REGIONAL REVIEW NOTICE

ARC REVIEW CODE: R1704171

Name of Proposal: Northwinds Summit (DRI 2669)

DRAWN BY	CHECKED BY
RCL	RCL
DATE	04/07/2017
SHEET TITLE	GRTA DRI SITE PLAN
SHEET NUMBER	DRI-1

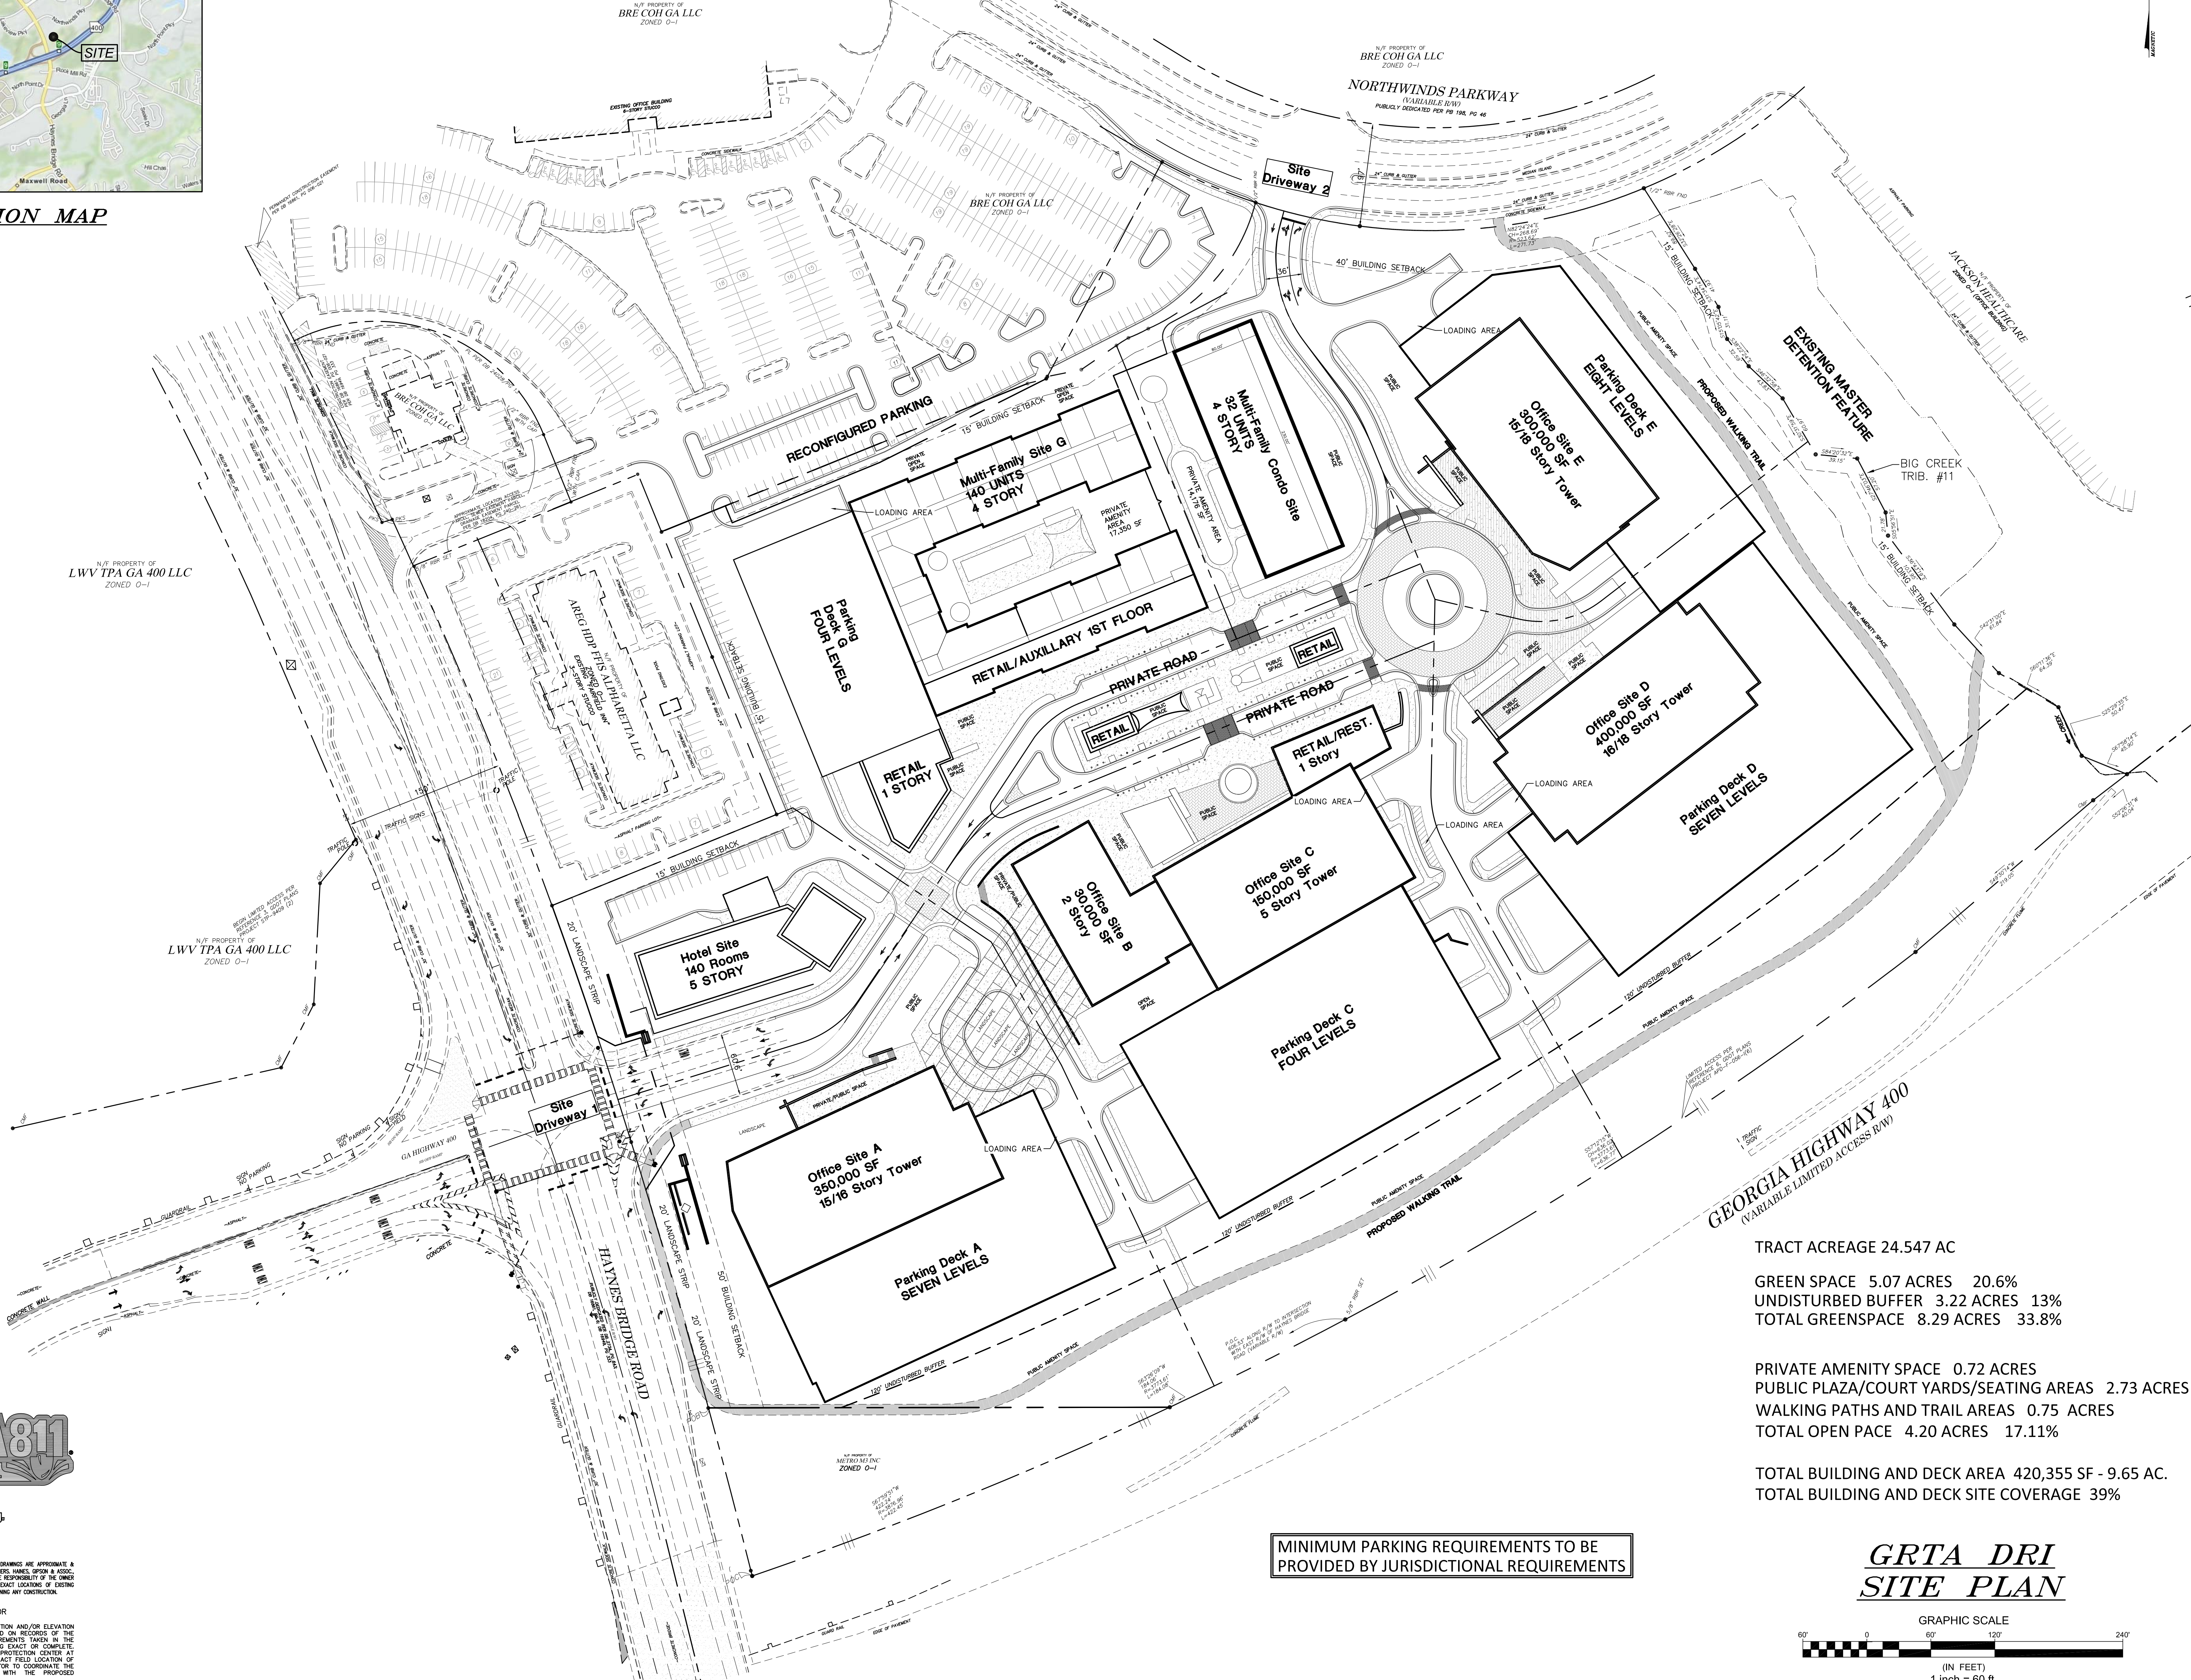
The USGS coverage for the project area shows an unnamed blue line stream running across the rear of the property from Northwinds Parkway to Georgia 400. It is identified on the submitted site plan as "Big Creek Tributary 11". A portion of the stream is an existing detention pond associated with the neighboring development and is partially located on this property, which is identified on the site plan as "Existing Master Detention Feature".

No buffers are shown on the stream, only a 15-foot building setback that is presumably the property line setback. A proposed walking trail is shown paralleling the creek and the detention pond, with another that ends at the property line and presumably will cross the stream. Behind the walking trail are parking structures E and D, which are shown on the site plan as approximately 40 -50 feet from the edge of the pond and 60-70 feet from the indicated stream channel. These impervious surfaces, as well as associated land disturbance, are subject to the requirements of the State 25-foot Sedimentation and Erosion Control buffer, as well as the City stream buffer ordinance's 50-foot undisturbed buffer and 75-foot impervious surface and may require a variance. Any unmapped waters of the State on this property will also be subject to the State 25-foot Sediment and Erosion Control Buffer.

The proposed development is within a quarter mile of Rock Mill Park and the Big Creek Greenway. Sidewalks provide pedestrian connectivity. Bicycle lanes currently do not exist adjacent to the park. The site depicts a proposed semicircular walking trail being provided on site as an amenity.

The development proposes a mixture of neighborhood uses including, office, accessory commercial and residential uses. Office and commercial uses currently bound the property on the west. The site plan does not depict consideration is being taken for future vehicular connectivity to adjacent parcels.

The site plan depicts a private drive providing vehicle access to onsite parking. While no crosswalks are depicted on the plan, sidewalks are provided along the exterior and interior roadways and driveways throughout the development and pedestrian connectivity is provided to neighboring uses. The site plan is unclear as to whether bicycle lanes are provided along the interior driveway.
